PCN-20190829 TEB0724-02 Under Voltage Protection Change

Company	Trenz Electronic GmbH
PCN Number	PCN-20190829
Title	TEB0724-02 Under Voltage Protection Change
Subject	Trenz Electronic TEB0724 Hardware Change
Issue Date	2019-09-05

affected product
TEB0724-02

#1 Replaced R40 by 953kOhm and R44 by 147kOhm

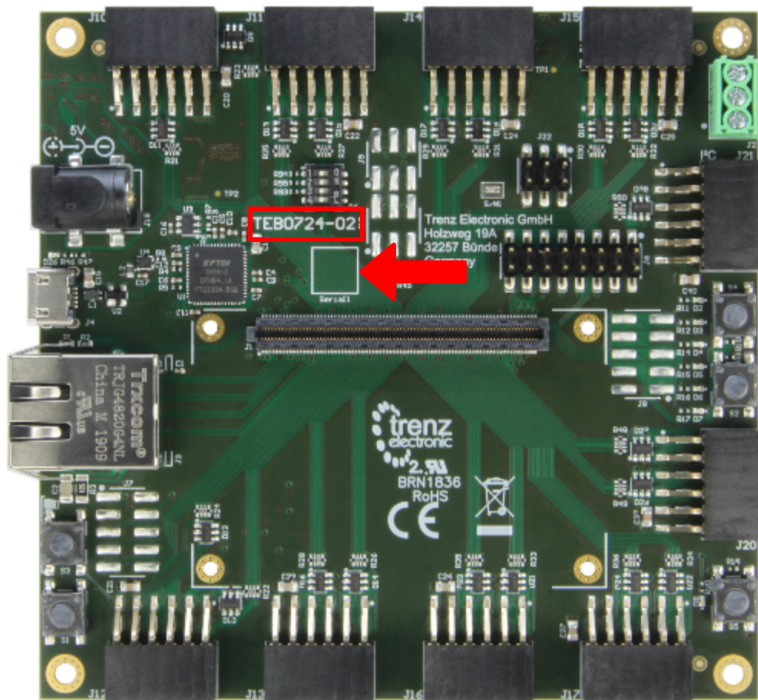
Type: BOM change

Reason: Large start up currents led due to adverse conditions (e.g. weak powersupply, long wires, increased contact resistance) to a voltage drop below the under voltage lock out limit of the input protection circuit.

Impact: Under voltage protection limit is decreased to 4.06V, which gives a larger margin for a voltage drop during start up.
